Payne Street Condominiums

Docket Item # 10
DSUP 2005-0014

DEVELOPMENT SPECIAL USE PERMIT #2005-0014
PAYNE STREET CONDOMINIUMS

Planning Commission Meeting
February 6, 2007

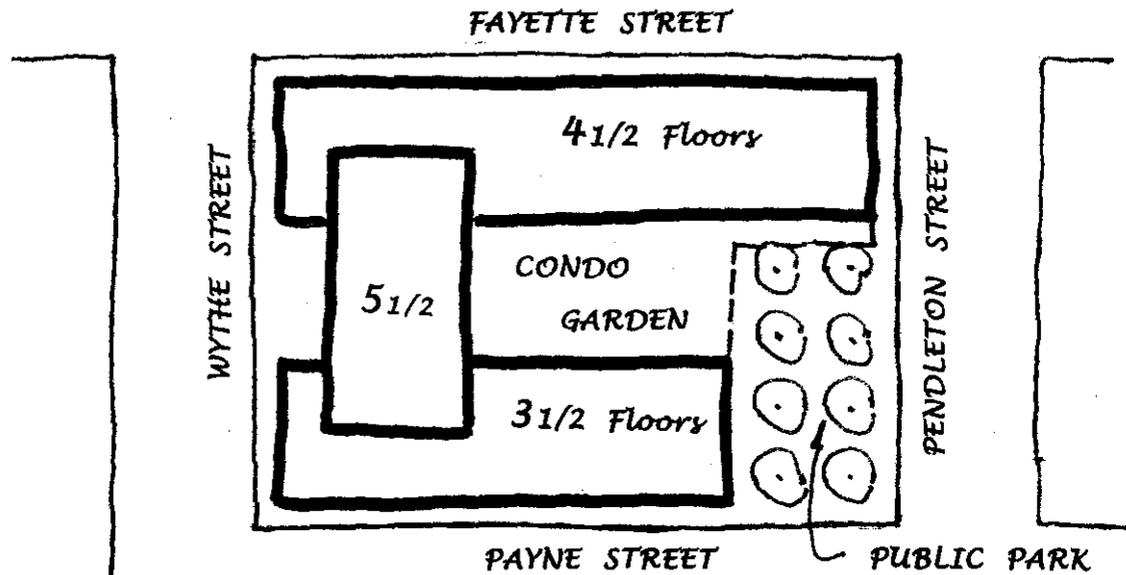
ALTERNATIVE PROPOSAL: Pictured below is an Alternative Proposal, which recognizes that Wythe Street will develop with five and six-floor buildings. This alternative frames a 5 1/2-floor central block between a 4 1/2-floor wing along Fayette Street, and a 3 1/2-floor wing along Payne Street. The Alternative Proposal has duplex units on the top floor-and-one-half – with dormer windows set into the roof; individual townhouse entrances on the street; and has the same floor area as the Jaguar proposal.

Notice that eliminating the dank northern alley permits the creation of two sunny gardens that face south. The first, the internal courtyard is reserved for Condo residents. The second, on the Payne-Pendleton corner, becomes a very attractive Public Park for the immediate neighborhood – while it buffers the two story townhouses to the west and south.

RECOMMENDATION: I would urge the Planning Commission to ask the developer, the Jaguar Group, to reconsider the obsolete logic of the current Payne Street Condo proposal and return next month with something more appropriate to the future of this block. While the Jaguar Group is understandably anxious to wrap up zoning approvals, a month of solid work would translate into a more marketable project. The Payne Street Condo neighbors will appreciate the time you devote to fine-tuning this Condo to a quality consistent with the best of Alexandria's legacy.

**STATEMENT OF RICHARD CALDERON
FOR THE COLECROFT STATION BOARD OF DIRECTORS
TO THE ALEXANDRIA CITY COUNCIL
REGARDING THE PROPOSED PAYNE STREET CONDOMINIUM**

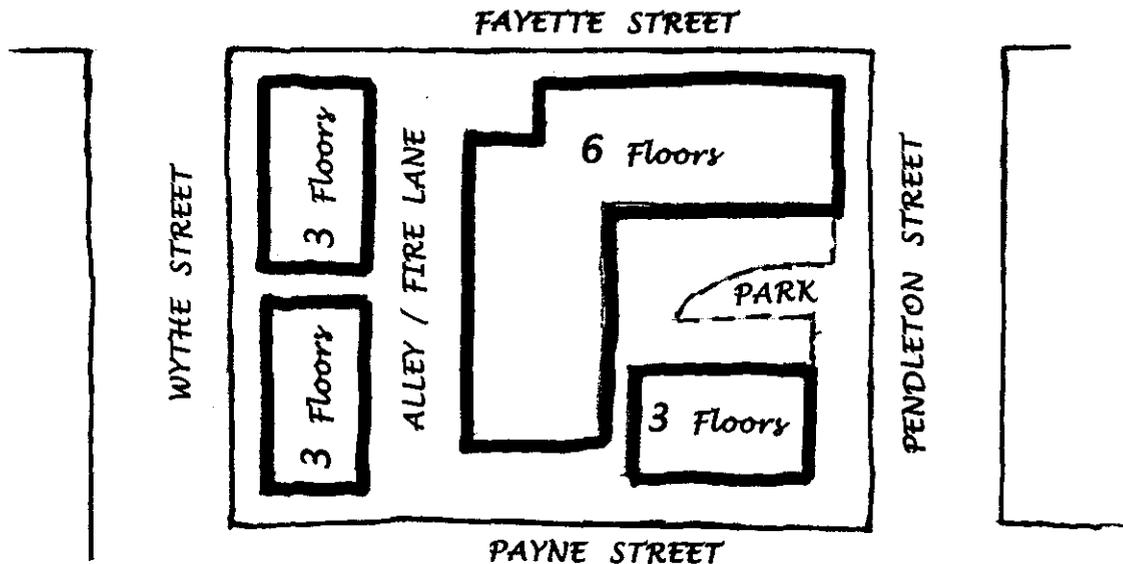
The current proposal by Hovanian is flawed by an obsolete decision to match three-floor housing across Wythe Street on the ARHA tract. Sadly, the Braddock Road Plan phases out the ARHA housing by raising FAR on the tract by 266% – if not more. ARHA has told residents that this is an opportunity the Authority will not pass-up. As a consequence, much taller buildings will dwarf Hovanian’s proposed three-floor, single-sided townhouses on Wythe Street. The single-sided townhouses facing south will have an exceptionally dismal view of a six-floor façade in perpetual shade, a sunless alley/fire lane and a garbage bay; which ugly prospect justifiably upsets existing Payne Street owners.

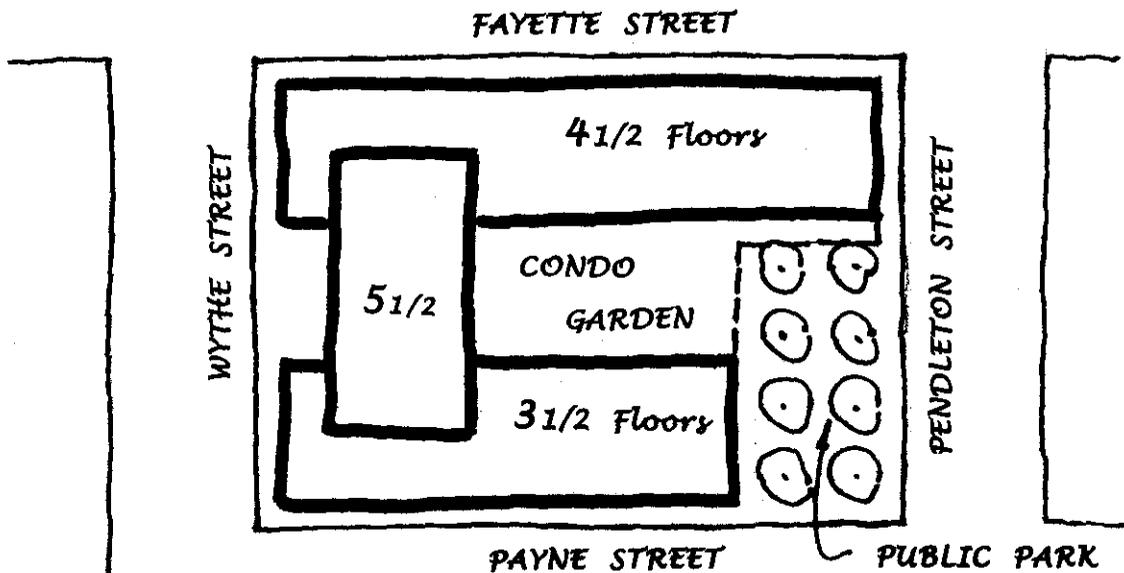
Given the wasted opportunity along Wythe Street, generated by obsolete assumptions about ARHA, Hovanian was forced to move square footage south into a six-floor, L-shape mass that overhangs two-floor homes on Pendleton, Payne and West Streets and wrecks views to and from the 610 Tower of Colecroft Station. Pressed for a ‘community benefit,’ Hovanian offers a narrow sliver of space – actually, a treeless fire lane – as a ‘Park’ to be maintained by the Condo. The private character of this open space will ensure friction between the Condo residents and the neighborhood and will cause endless City Hall wrangling to deny neighborhood access in the future.

ALTERNATIVE PROPOSAL: Pictured below is an Alternative Proposal, which recognizes that Wythe Street will develop with five and six-floor buildings. This alternative frames a 5 1/2-floor central block on Wythe Street between a 4 1/2-floor wing along Fayette Street, and a 3 1/2-floor wing along Payne Street. This alternative has duplex units on the top floors – with bedroom dormer windows set into the roof; individual townhouse entrances on the street for the units below; and more FAR than the Hovanian proposal – which permits tweaking building mass. Losing Hovanian’s dank alley permits the creation of two sunny gardens. The first, an internal courtyard covering the garage is reserved for Condo residents. The second, on the Payne/Pendleton corner, is a Public Park with deep-rooted trees for neighbors – a leafy place buffering two-floor townhouses to the west and south.

RECOMMENDATION: On 6 February 2007, the Planning Commission recommended approval of the current proposal based on groundwork done in 1997 before the Braddock Road Area Plan. City Council should task Hovanian to abandon the obsolete 1997 logic of the current proposal and return next month with a proposal appropriate to planned conditions in 2010 - 2020. While Hovanian is anxious to wrap up approvals, the City Council’s commitment to give a 2.5 FAR is not in doubt. A week of work by Hovanian’s strong design team would produce a less costly, more marketable and more profitable project. And the neighborhood would benefit with more sensitive massing on Payne and Pendleton Streets and a truly useable and beautiful Park.
